PLANNING COMMITTEE A

Committee	PLANNING COMMITTEE A – Addendum	
Report Title	Willow Tree Riding Establishment, Ronver Road, SE12 0NL	
Ward	Grove Park	
Contributors	Georgia McBirney	
Class	PART 1	27 February 2020

Representations in response to the planning committee report

**Project: Willow Tree Riding Establishment, Ronver Road, London, SE12
ONL (DC/19/111719)**

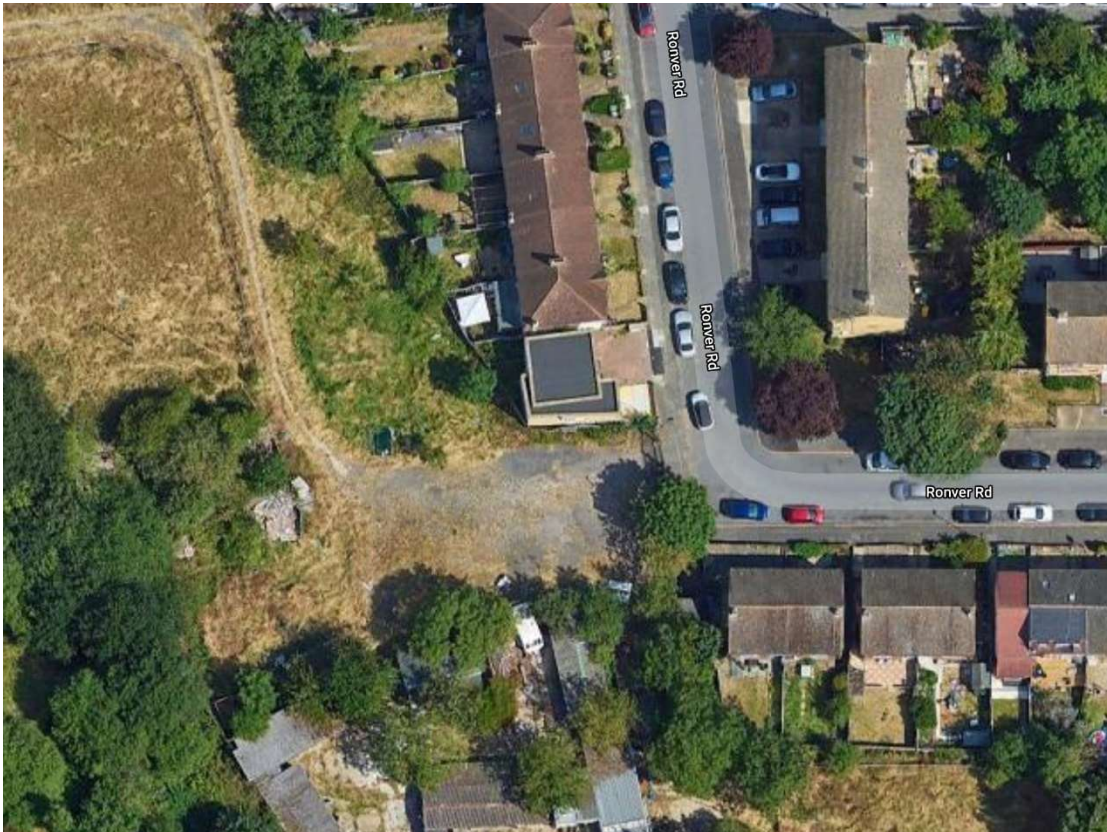
The only access point to the site is from the existing vehicular access on Ronver Road, which is not wide enough for 2-way vehicle movements. The current application does not propose any changes to the existing access. So users and visitors (pedestrians, cyclists and vehicles) would access the site via the existing access gate.

The gated shared access is approximately 5.5m, therefore, is wide enough for 2 cars. The arrival and departure numbers are low as assessed in the Transport Statement. A 1-2m footway can, however, be accommodated around the site. Notwithstanding this, the lawful use of the site is already an established riding stables for up to 40 horses. The development proposes to only stable 26 horses resulting in a betterment overall on the site in regards to access and traffic. The local highway authority, therefore, should take account of this fallback position where the existing site can continue to be operated for up to 40 horses.

Figure 1: Car and Horse Trailer Tracking

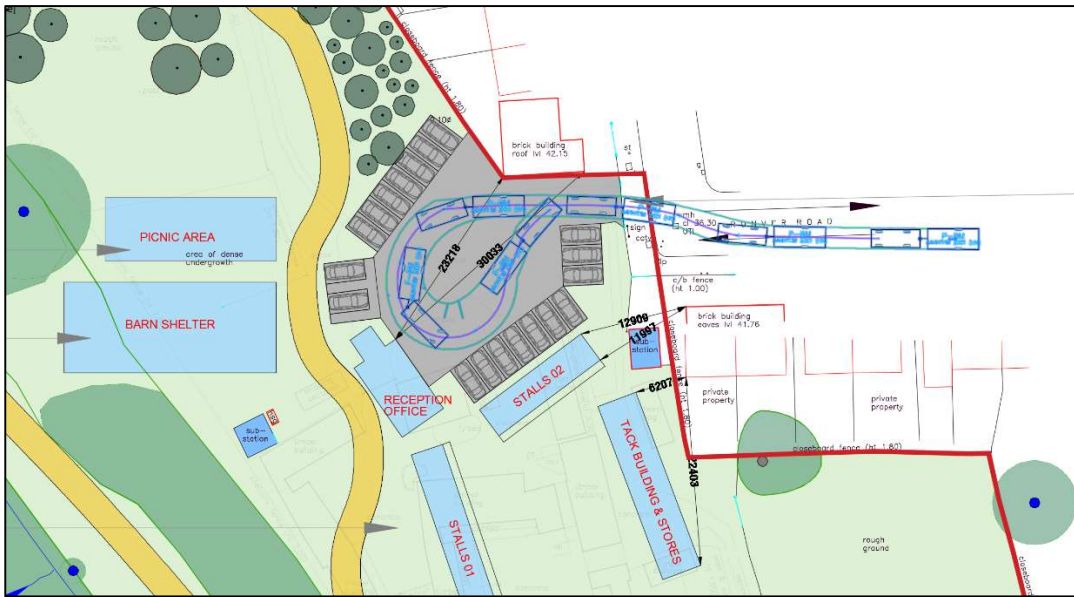
No swept path analysis is provided to demonstrate that large vehicles can access / egress the site in forward gear within the new sit layout (location of proposed buildings and track adjacent to car park area).

Tracking of a Car and Horse Trailer is provided in Figure 1 which shows that it can enter and exit in a forward gear whilst Figure 2 shows a 10m Large Truck.

Figure 2: 10m Large Truck Tracking

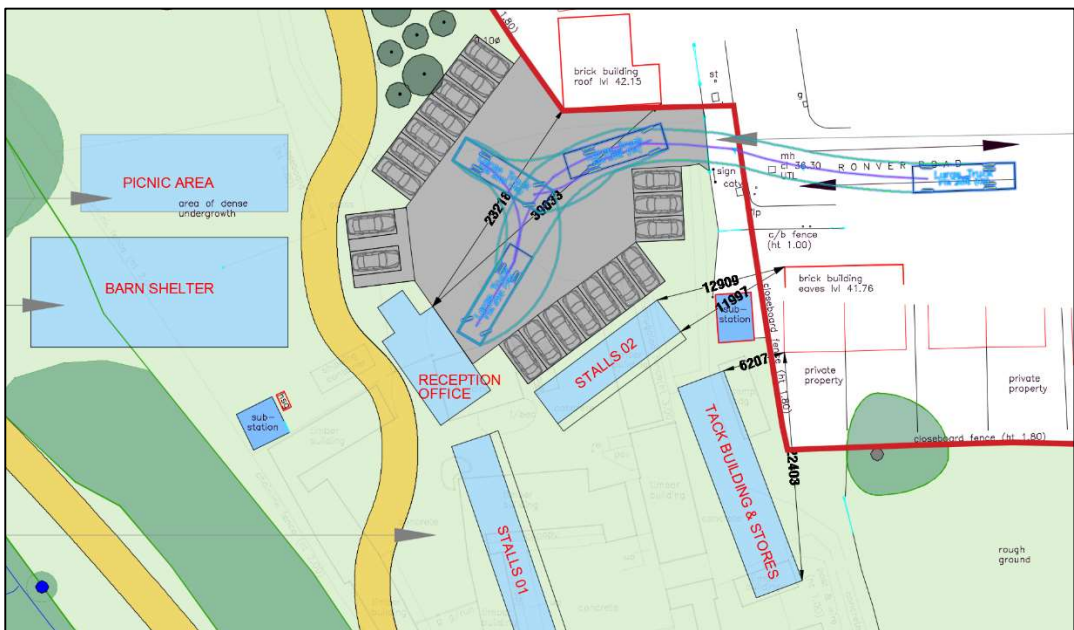
- 11 In response to point 17, the Highways Officer highlights that safe pedestrian and disabled access to the site should not be secured by condition given the building configurations. The Highways Officer also highlights that the TRICS data in Appendix AD1 is not comparable and the swept path drawings are not scalable.
